VIRGINIA POWER

In accordance with ES 201 of NUREG 1021 Virginia Electric and Power Company hereby makes official submittal of comments concerning the NRC examinations administered at the North Anna Power Station February 16 through 26, 1988.

NORTH ANNA POWER STATION
COMMENTS ON WRITTEN NRC EXAMINATIONS
ADMINISTERED ON FEBRUARY 16, 1988

FIGURE 1-1

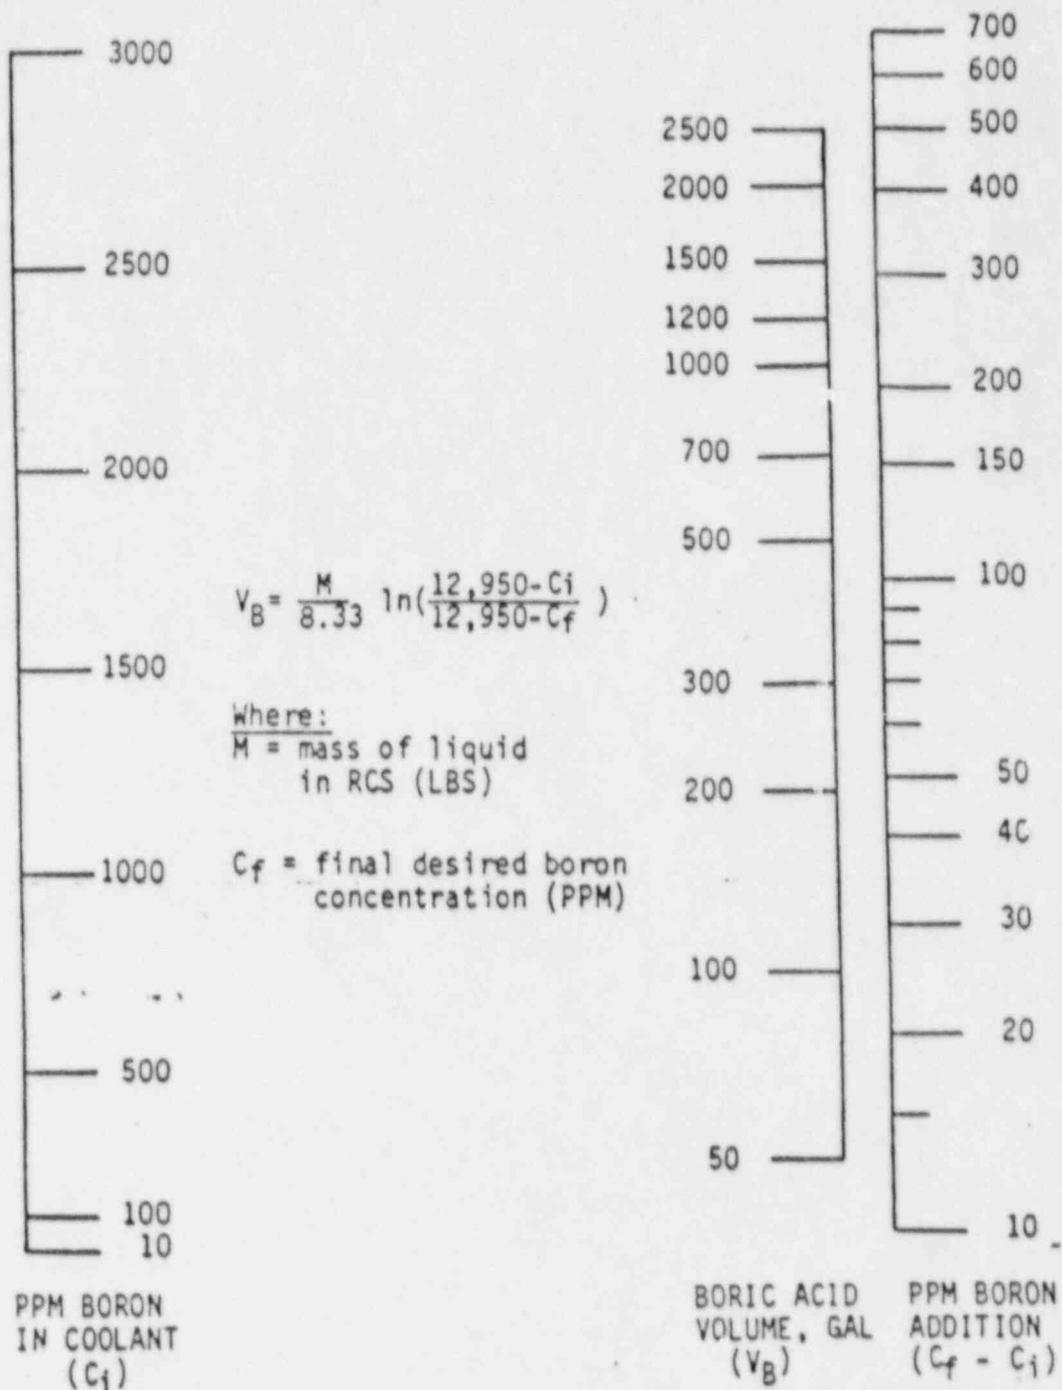
Comment: The answer key does not take into account the greater density of the RCS at temperatures below operating temperature. The greater density of the RCS requires more boric acid per ppm than at operating temperatures. Consequently, either the NOMOGRAPH CORRECTION FACTORS of Figure 1.3 should be applied or the equation

should be used. The nomographs of Figure 1.1 are accurate only at operating temperatures, and it is incorrect to use them unadjusted since they will underestimate the amount of boron required, which is a nonconservative error. In addition, the question does not specify at what temperature the -2200 pcm of reactivity is to exist. If it is 500°F, then the NOMOGRAPH CORRECTION FACTOR is 1.05 and approximately 1280 gallons of Boric acid would be required. If it is cold shutdown temperature of 100°F, then the correction factor is 1.47 and about 1800 gallons of Boric acid would be required. Also, not knowing temperature means that the student does not know what value to use for the mass of the RCS if he chooses to work the problem using the equation

An additional minor point is that the concentration in the Boric Acid Storage Tanks should be specified as 12,950 ppm. North Anna Technical Specifications allow the Boric Acid Storage Tank concentration to be between 12,950 ppm and 15,750 ppm. If the concentration is anything other than 12,950 ppm, then the nomographs of Figure 1.1 are inaccurate. Although, any error in this case is conservative.

Recommendation: Change answer key to include the use of NOMOGRAPH CORRECTION FACTORS and accept any NOMOGRAPH CORRECTION FACTOR as correct since the temperature is not specified. Also, count as correct the use of equation

and accept any assumed value for M, once again because the temperature is not specified.
